## ADDENDUM NO. 2(TWO)

| <b>Issue Date:</b>             | October 1, 2025        |
| <b>School / Facility Name:</b> | University High School |
| <b>Project Name:</b>           | Extend Parent Loop     |

# C100

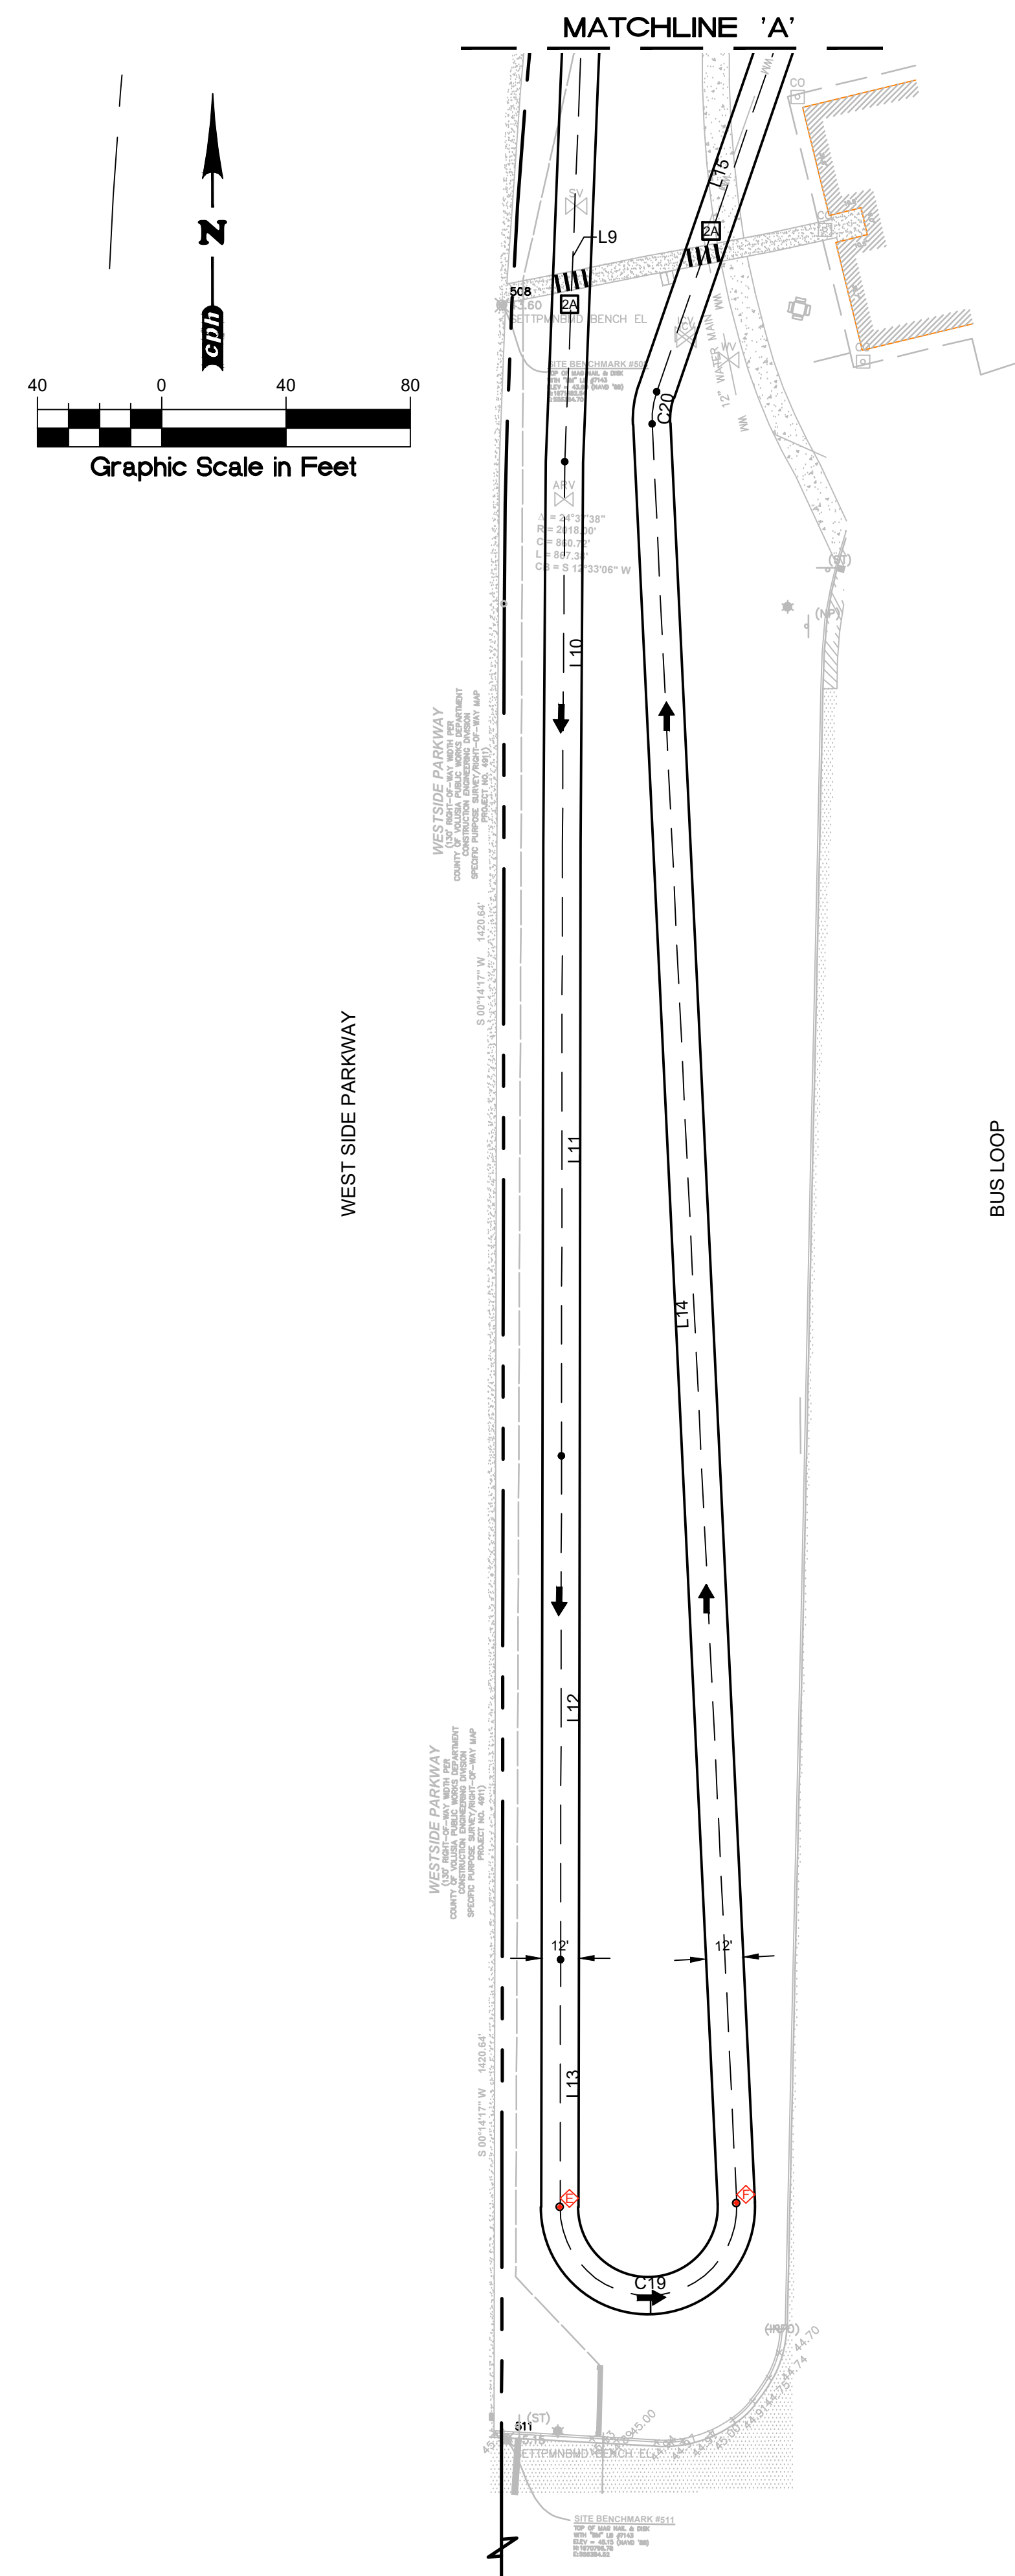
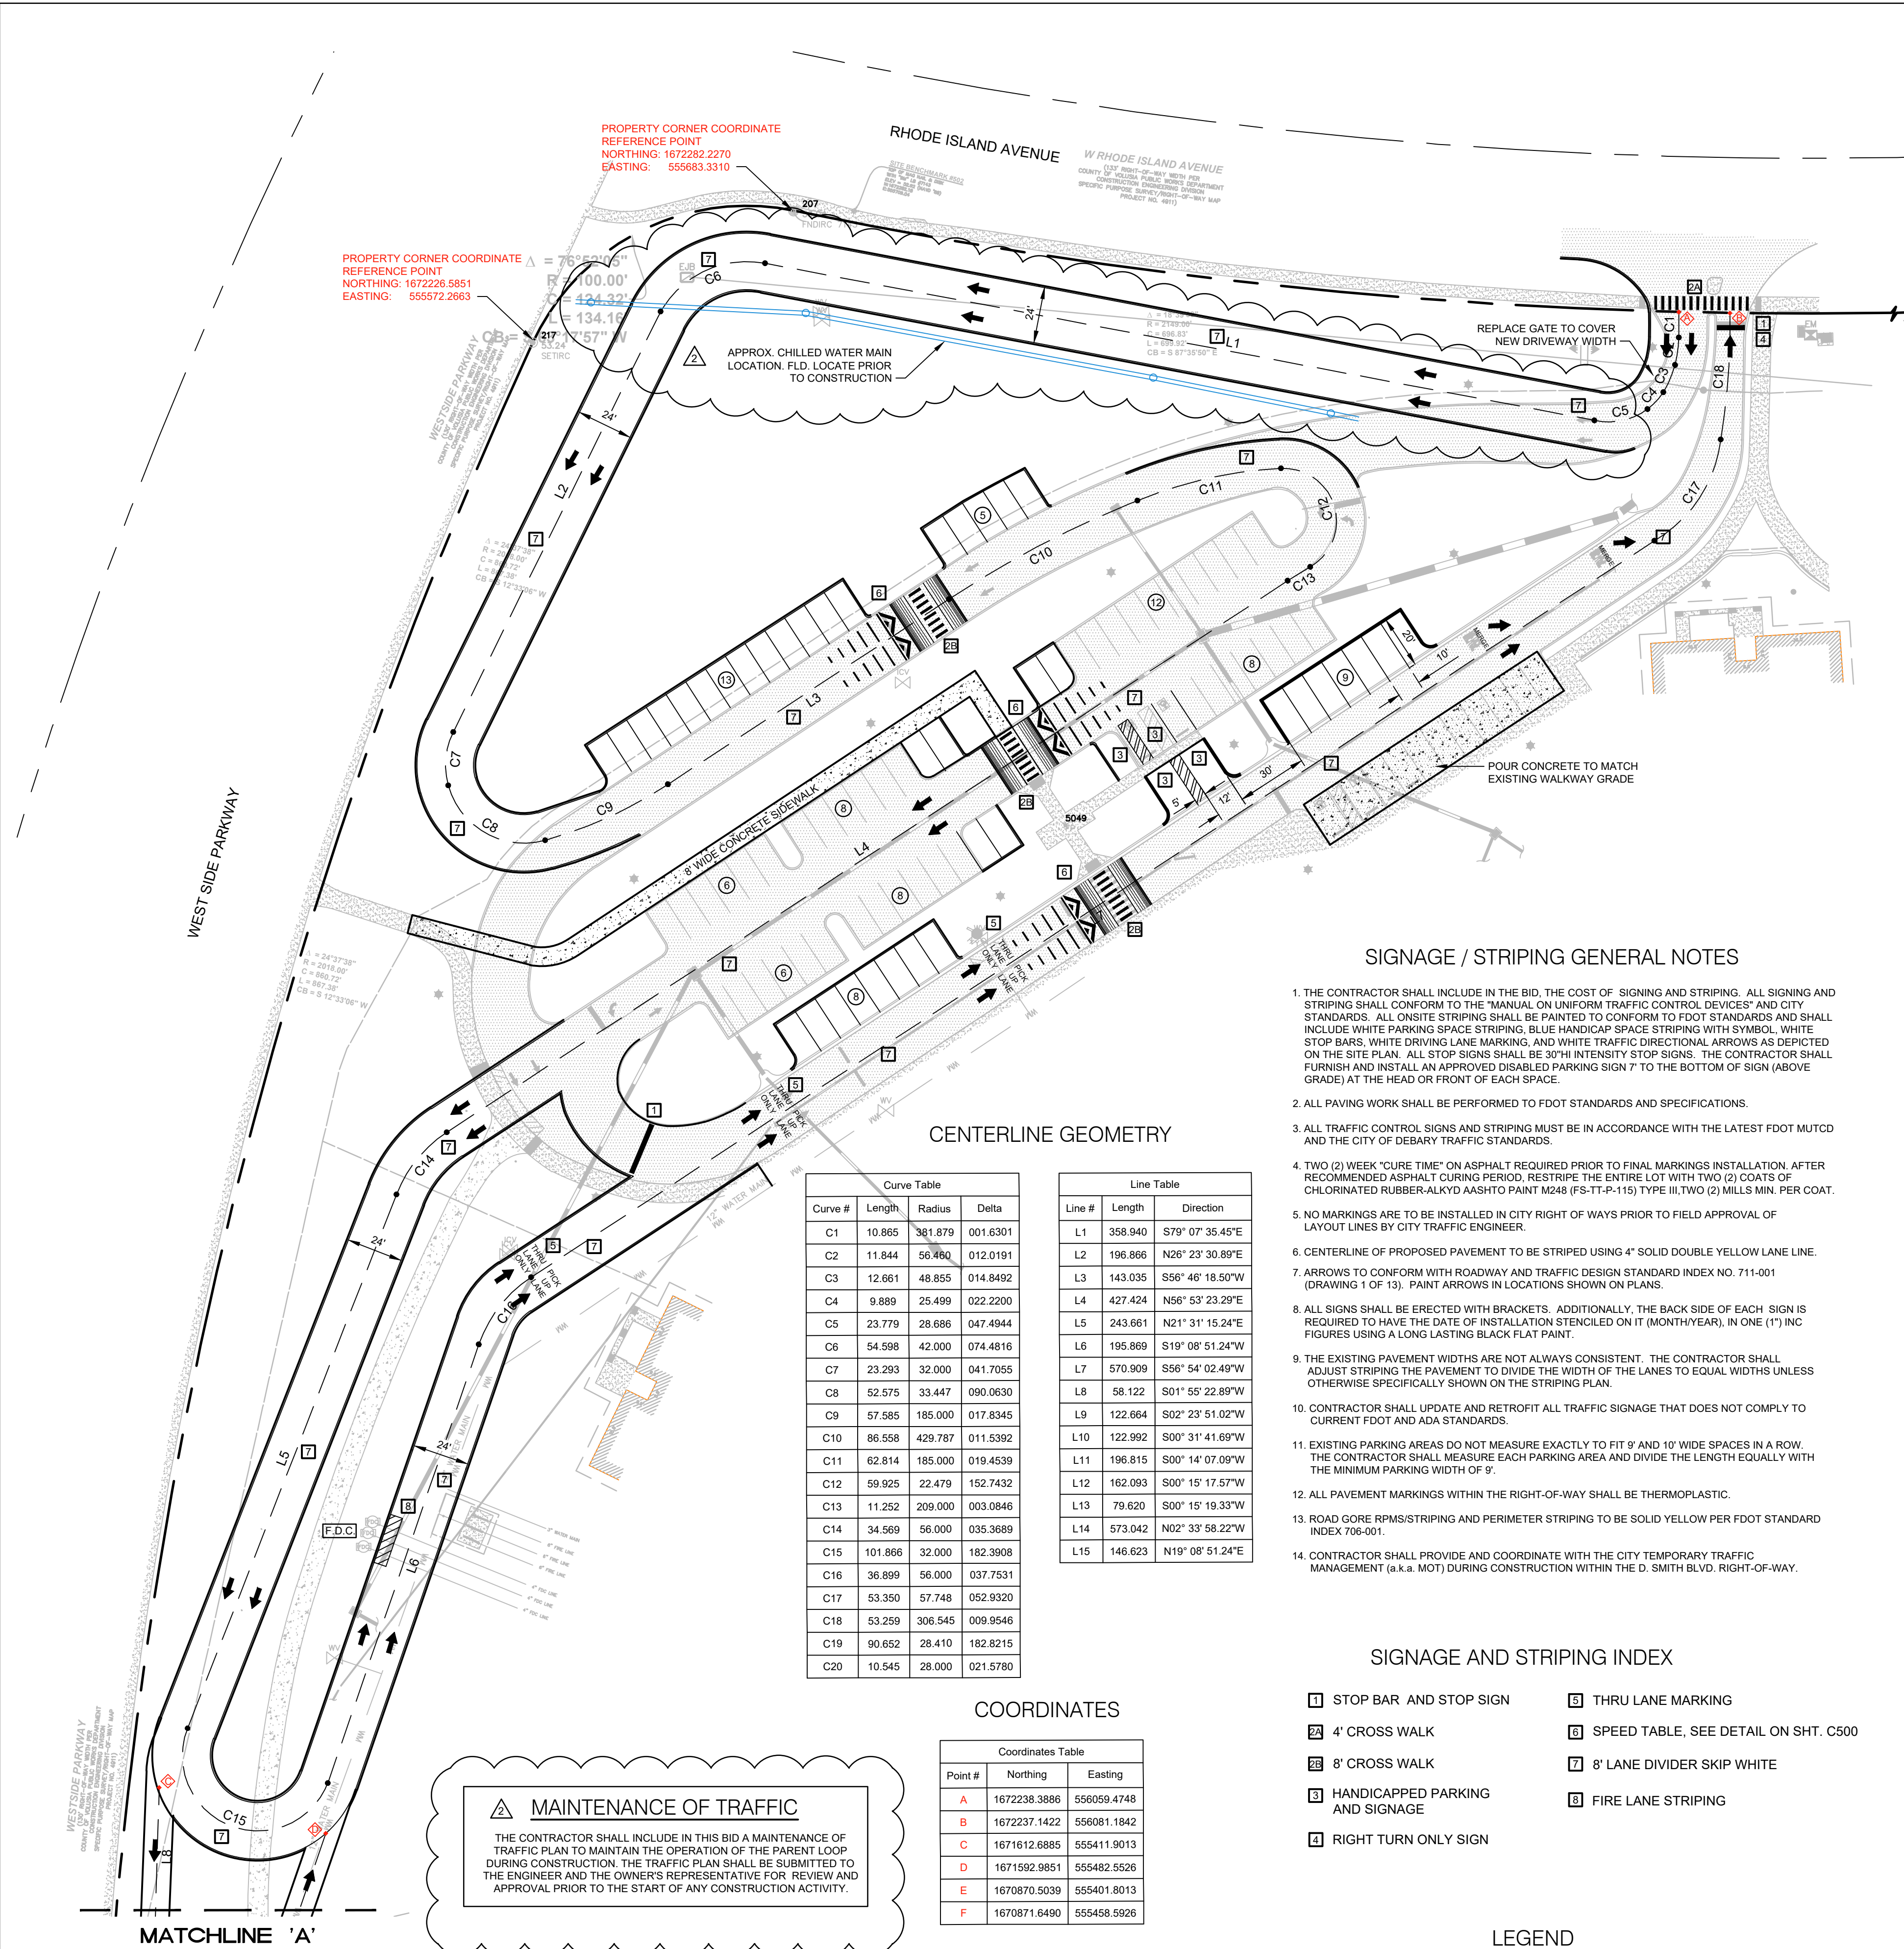
#### **I. C100 DEMOLITION PLAN**

- A. Add Temporary Fencing Note #13.
